## Department of Transportation

#### MEMORANDUM

**SUBJECT:** ZC Case No. 22-28 – 1100 South Capitol Street SE

**Figure 1 | Site Plan**

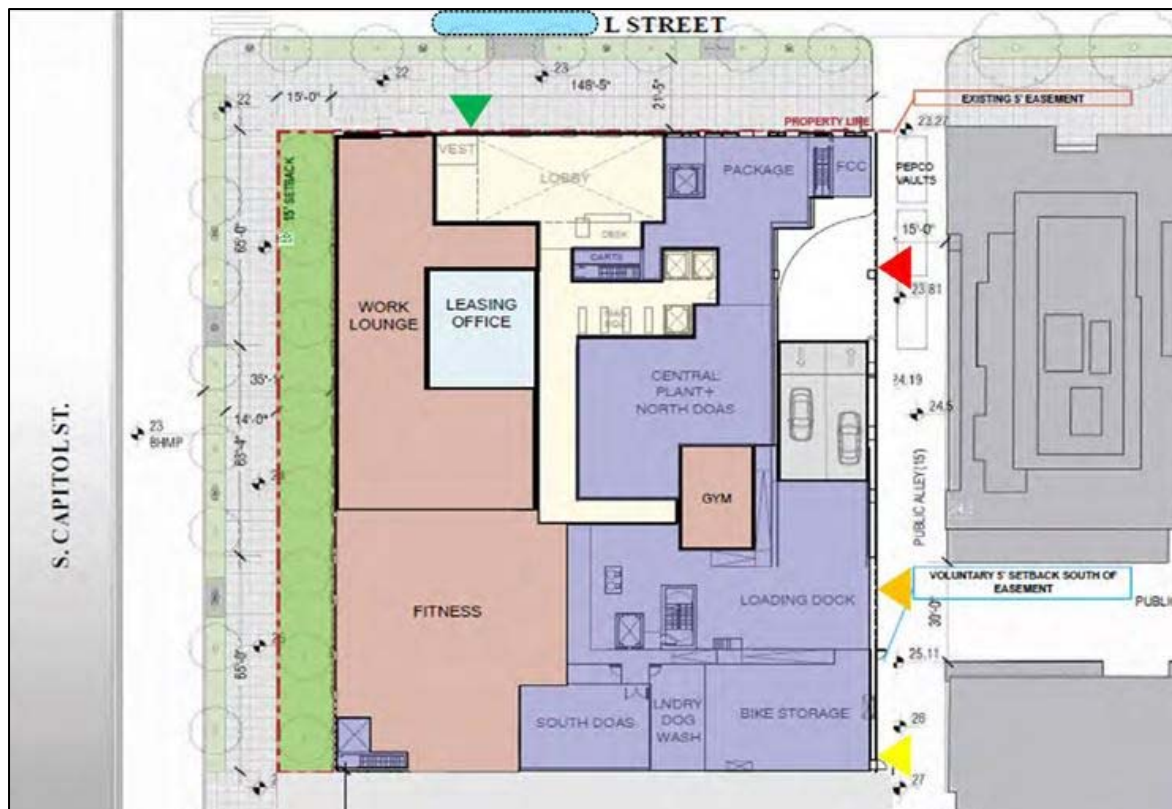
While the preliminary public space plans, shown above in Figure 1, are generally consistent with DDOT standards, there are several considerations that need to be reviewed in greater detail during the public space permitting process:

- Refer to the South Capitol Streetscape Guidelines for the design of the area in public space, as well as the private space with in the 15-foot setback. DDOT is currently updating the guidelines so flexibility in this design is requested in the Zoning Order;

- Close the existing curb cut to the South Capitol Street service lane. No new curb cuts should be proposed to any public street. All vehicular site access to the site, as well as loading facilities and trash pick-up, must be via the existing rear public alley network;

- Submit a detailed curbside management plan with proposed signage for the PUDO zone proposed on L Street SE for review and approval by DDOT Curbside Management Division (CMD). If CMD requires multi-space meters for the remainder of the frontage, they will be at the Applicant’s expense;

- Install missing street trees along L Street SE;
- In accordance with the District’s policy prohibiting right-turns on red at signalized intersections, install No Right Turn on Red signage at each signalized intersection surrounding the site;

**Figure 6 | Proposed Curbside Designations**

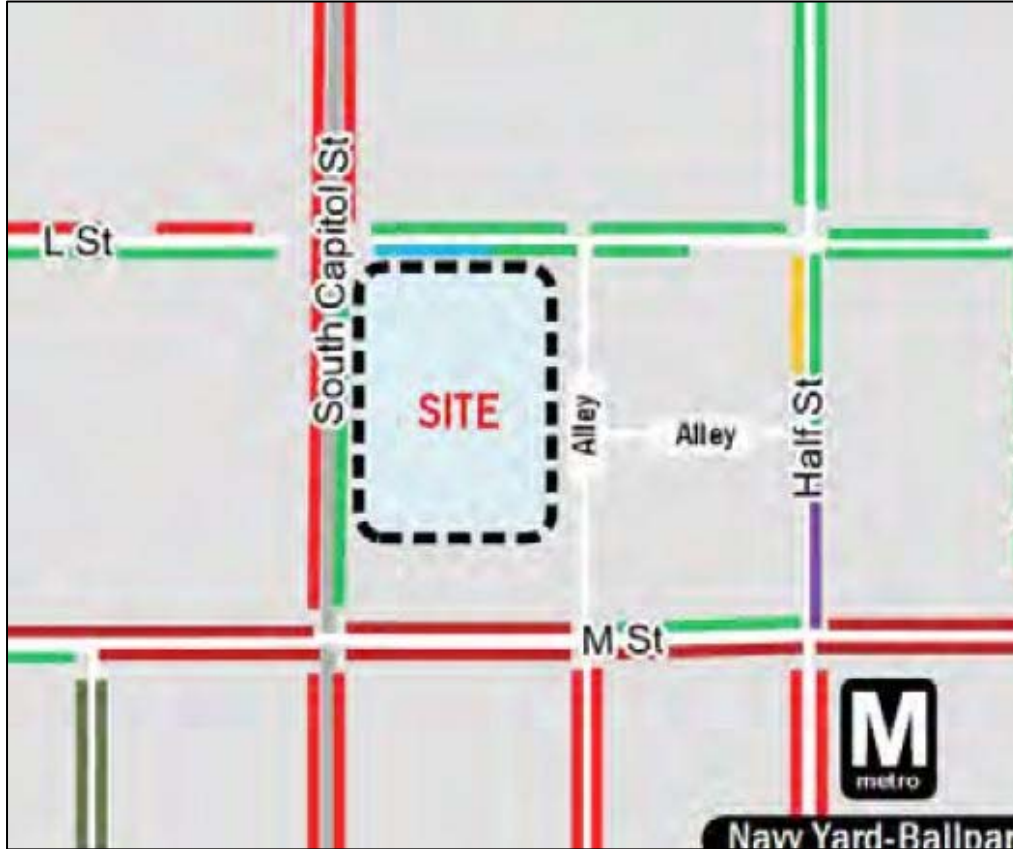
As shown below in Figure 6, the Applicant is requesting an on-street pick-up/drop-off zone (blue line) near the building entrance on L Street SE while leaving the remainder of the blocks as metered.

DDOT is generally supportive of this concept, however, a detailed curbside and signage plan must be submitted during public space permitting for review and approval by DDOT’s Curbside Management Division (CMD). At that time, the plan may be refined by CMD and the exact signage placards will be determined. If multi-space meters are required by CMD then they will be at the Applicant’s expense.
